# Recall Bulletin

**SUBJECT:** Engine Compartment Fire

**MODELS:** 1997-2003 Buick Regal GS  
1997-2003 Pontiac Grand Prix GTP  
Equipped with a 3.8L V6 Supercharged Engine (RPO L67 – VIN 1)

**This bulletin is being revised to update the correction, service procedure, parts information and the warranty transaction information. Please discard all copies of bulletin 07035A.**

2076766

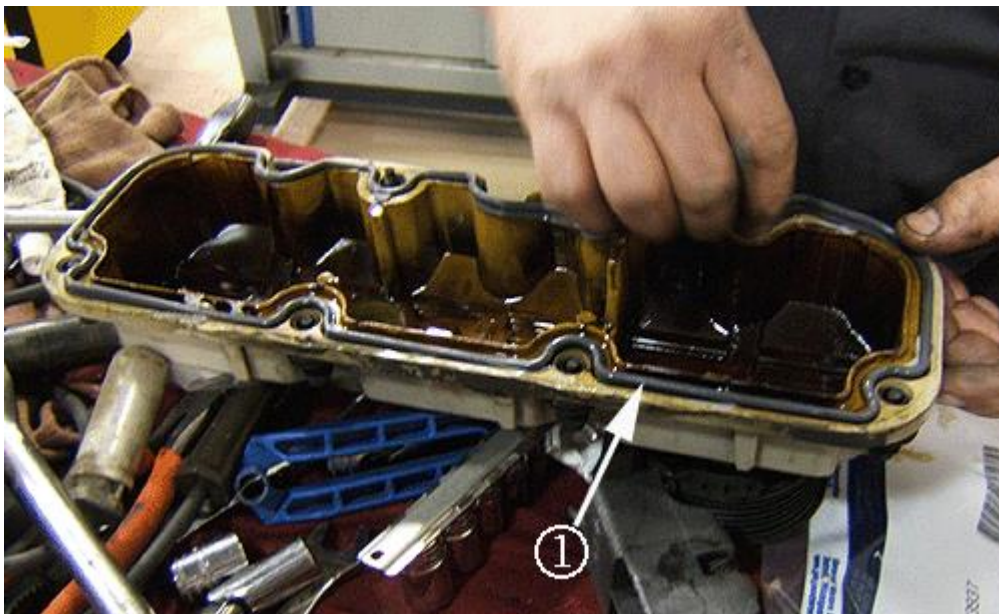
6. Install a new left or front valve cover gasket (1) into the new valve cover and make sure that the valve cover gasket is seated properly in the valve cover groove. The old valve cover is shown for illustrative purposes only.
  - 6.1. Install the six valve cover bolts and the six grommets into the valve cover.
  - 6.2. Apply medium strength thread lock compound (blue) to the six valve cover bolt threads.
  - 6.3. Install the valve cover and gasket (1) to the cylinder head.
  - 6.4. Tighten the valve cover bolts to 10 Nm (89 lb in).
